REPORT TO THE BELOIT LANDMARKS COMMISSION

Meeting Date: June 21, 2011

File Number: COA-2011-06

Location: 910 Emerson Street

*** Here are the wall configurations for your design.

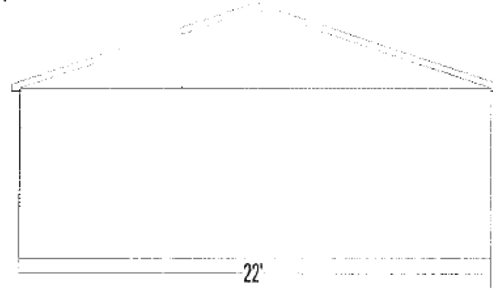
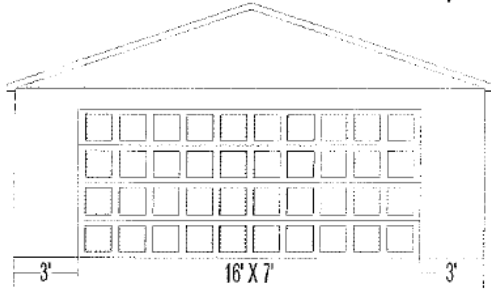
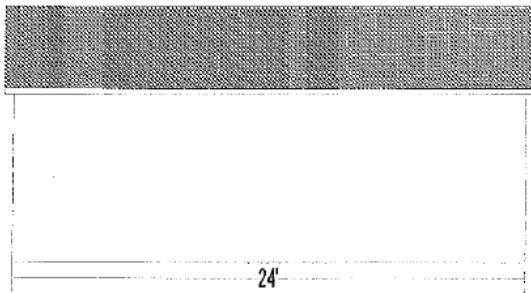
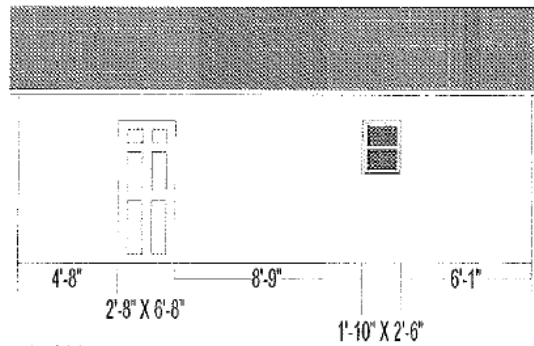
With a peak height of twelve (12) feet, the proposed garage is shorter than the historic house, which is consistent with an accessory structure's relationship to a primary structure. With respect to height, the proposed garage is compatible with the style and character of the historic district.

The proposed gable roof is compatible with the architectural style of the historic house.

The proposed materials are relatively common, contemporary materials that are readily available at home improvement stores. While they are not ideal, most of the proposed materials are compatible with the house and the larger historic district. However, the applicant has proposed the use of vinyl double 4" lap siding that does not have a smooth or brushed stroke finish. The proposed siding is incompatible with the house and the larger historic district, and staff is recommending a condition of approval to address this issue.

1. With the exception of the siding, the applicant shall use the materials that were described and illustrated in the application and attachments.
2. Prior to issuance of a Building Permit, the applicant shall submit a revised vinyl siding material sample for Planning staff review and approval. The vinyl siding shall have a smooth or brushed stroke finish.
